UNITED STATES PATENT AND TRADEMARK OFFICE

10/670,168

Office Action Summary	Application No. 10/670,168	Applicant(s) VARDI ET AL.	
	Examiner ELIZABETH HOUSTON	Art Unit 3731

DETAILED ACTION

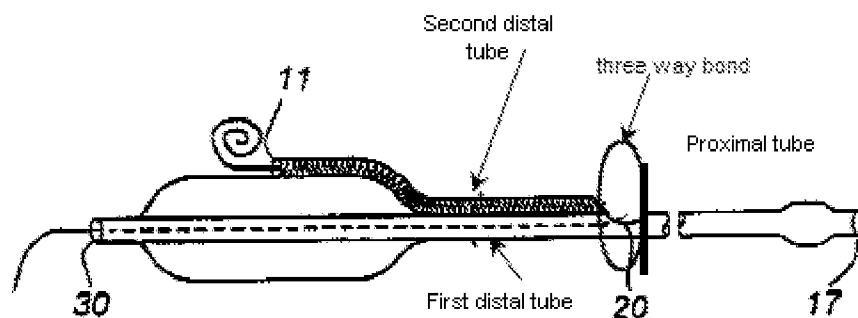
10. Ischinger discloses a catheter comprising: a proximal tube terminated at a distal open end; a assembly comprising a first tube (channel having main guidewire lumen) terminated at a proximal open end (main exit port) and a second tube (branch guidewire enclosure) terminated at a proximal open end (branch exit port), wherein said first tube is configured to receive a first guidewire and said second tube is configured to receive a second guidewire; and a three-way bond coupling the distal open end of the proximal tube to said proximal open end of said first tube and to said proximal open end of said second tube; wherein the second tube of the distal assembly is bonded to the first distal tube only at (near) the three-way bond. The main exit port is located at a distance from the distal end that is substantially equal to the distance of the branch exit port from the distal end. The distance is less than a distance from the distal to the proximal end of the

catheter and greater than a distance from the distal end of the catheter to the proximal end of the stent. The proximal end of the bond connects to the distal end of the proximal tube and the distal end of the bond connects to the proximal open end of the first distal tube and the proximal open end of the second distal tube. The second distal tube is detached from the first distal tube outside of the bond (where the second distal tube is attached to the balloon - see below). There is a balloon and inflation lumen. The first tube is attached to the second tube external of the three way bond (between the bond and the balloon - see below) and along an entire length of the second tube (Fig. 1D). The three way bond is a predetermined distance and the proximal tube connects to the three way bond at a location spaced from the distal portion connecting to the three way bond (see below). The guidewires exit at the three way bond.
